Access Compliance Report

Public Rights-of-Way

(Curb Ramps)

| Intersection ID: 15195 | Main Street: ALBEMARLE_RD | Cross Street: FARM_POND_LN | Location: SW |

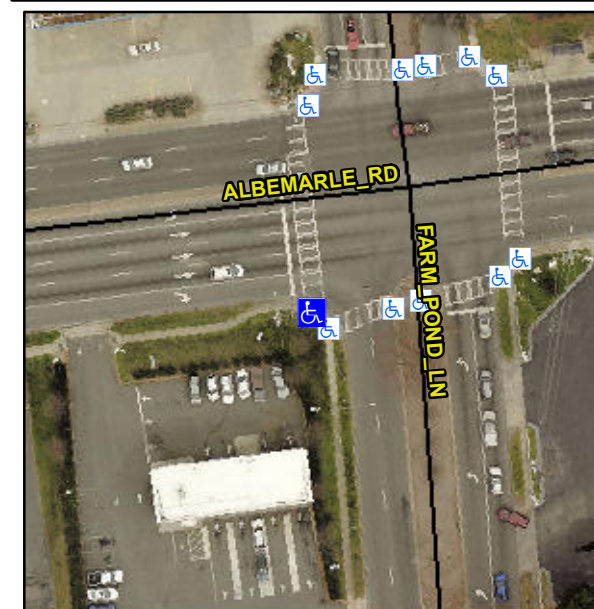
| ADA ID: 0C1673F17B1D | Ramp Type: Perp | Initial Pass/Fail: Fail | Overall Compliance: No |

Not Found, R304.5.1

| Compliance | Description | Data | Compliance | Description | Data |
|------------|-----------------------|-------|------------|-----------------------------|------|
| No | Ramp Width (in) | 45.5 | Yes | Ramp XSlope (%) | 1.8 |

Remove & Replace Entire Ramp.
